Product Change Notification

113547 - 00

Change Notification #: 113547 - 00
Change Title: Intel® Server System R2312GL4GS
PCN 113547-00, Product Design
Update the System Rear Panel, Resistors and
Capacitor
Date of Publication: December 22, 2014

Figure One

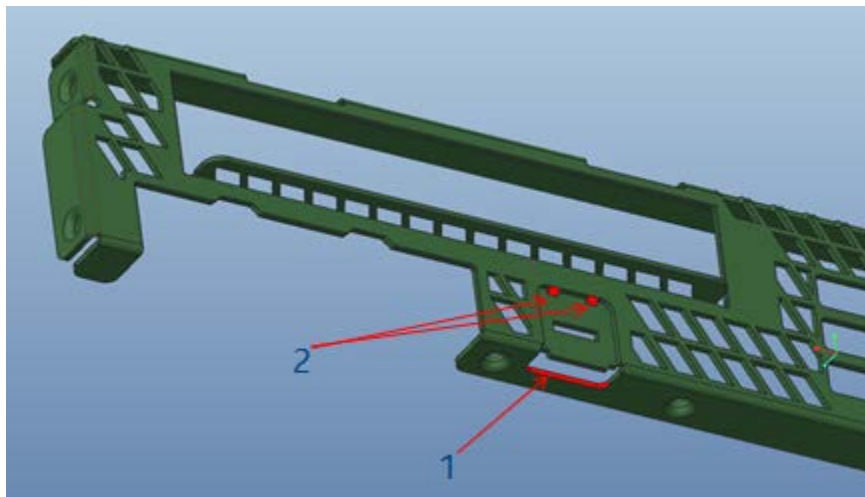
1. Add a connection at the bottom of the RMM4 (Remote Management Module 4) slot to improve structure strength. See item 1 in the Figure One.
2. Update the one big center joint to two smaller joints so that the joints will not conflict with the LAN cable connector latch. See item 2 in the Figure One.

Figure Three

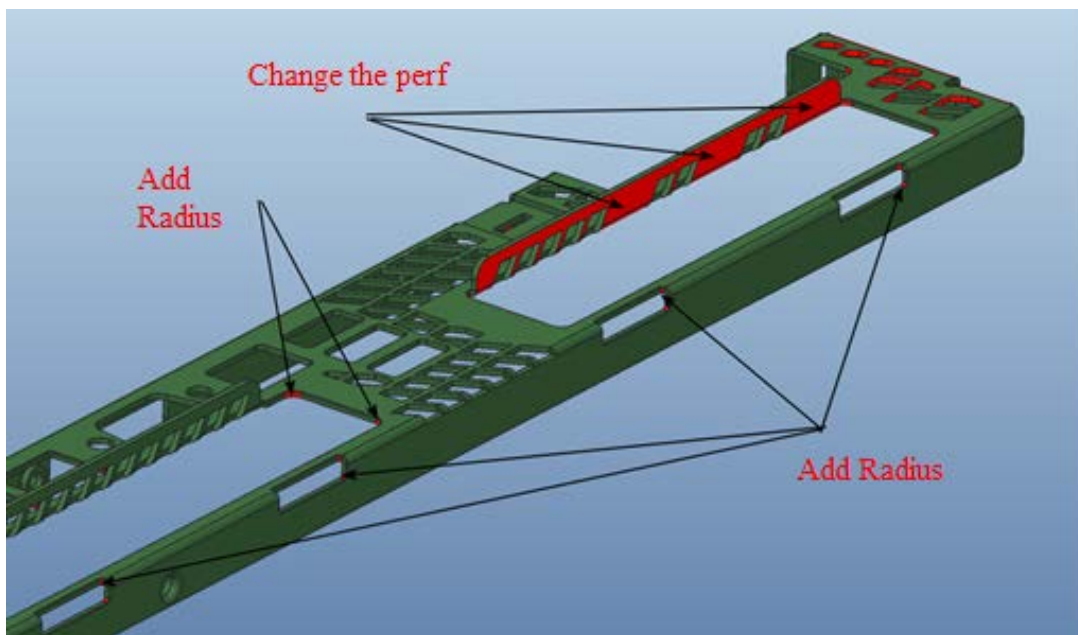
4. Update the perf and add radius to improve structure strength. See the Figure Three and Four.

Figure Five

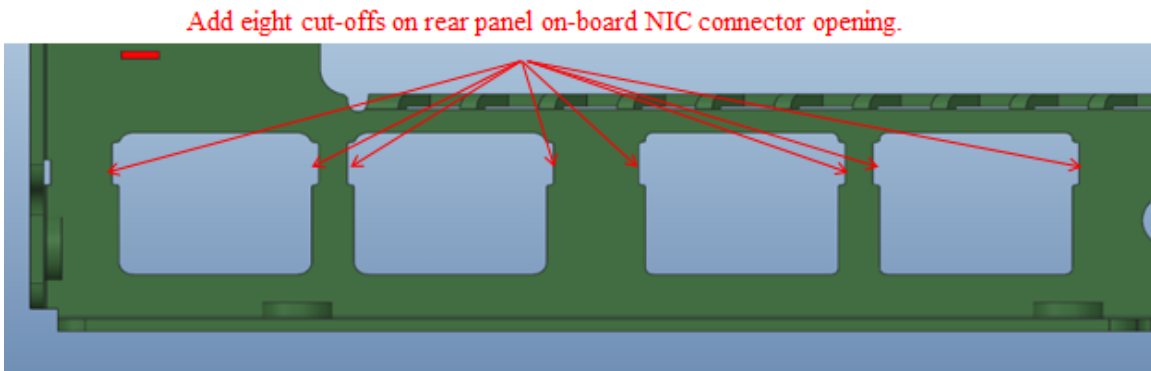
5. Add eight cut-offs around the on-board NIC (Network Interface Controller) openings to improve the LED visibility. See the Figure Five.

Figure Six. Component Locations for the 2U Riser Spare A2UL8RISER

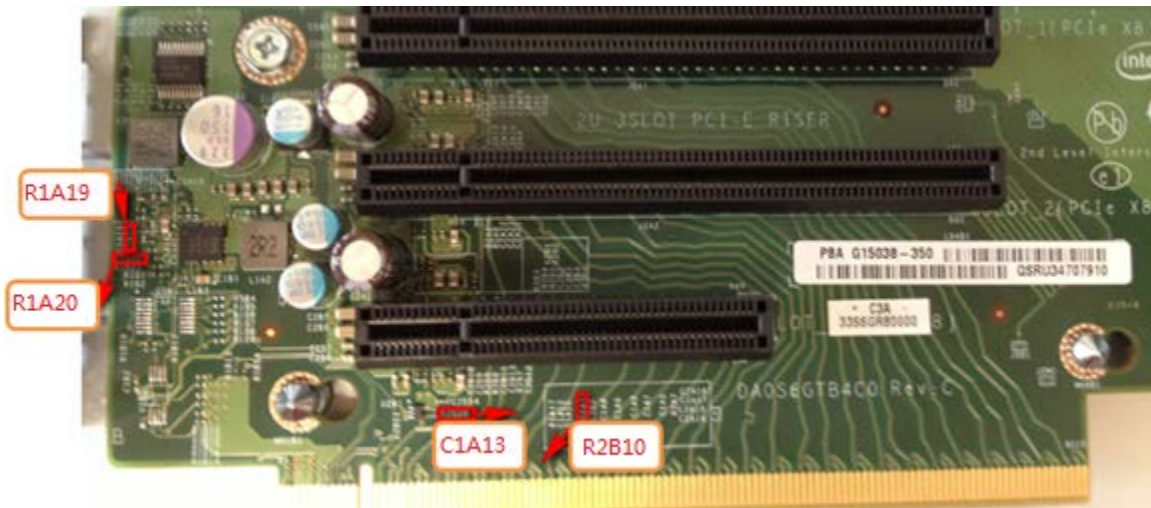
6. Update the following resistors and capacitor (see Table One and Figure Six) on the 2U PCIe Riser Spare A2UL8RISER to make an improvement to support a higher 3.3 Voltage Regulator startup over current. Before this change, the Voltage Regulator on the riser card may not be able to turn on when the total current drawn is more than 5A current. After this change, the Voltage Regulator on the riser card can support more than 10A current.

Component	Location	Pre-change	Post-change
Resistor	R2B10	10.00 kOhm	3.65 kOhm
Resistor	R1A20	0 Ohm	30 Ohm
Resistor	R1A19	40.20 kOhm	20.00 kOhm
Capacitor	C1A13	10.00 pF	120.00 pF
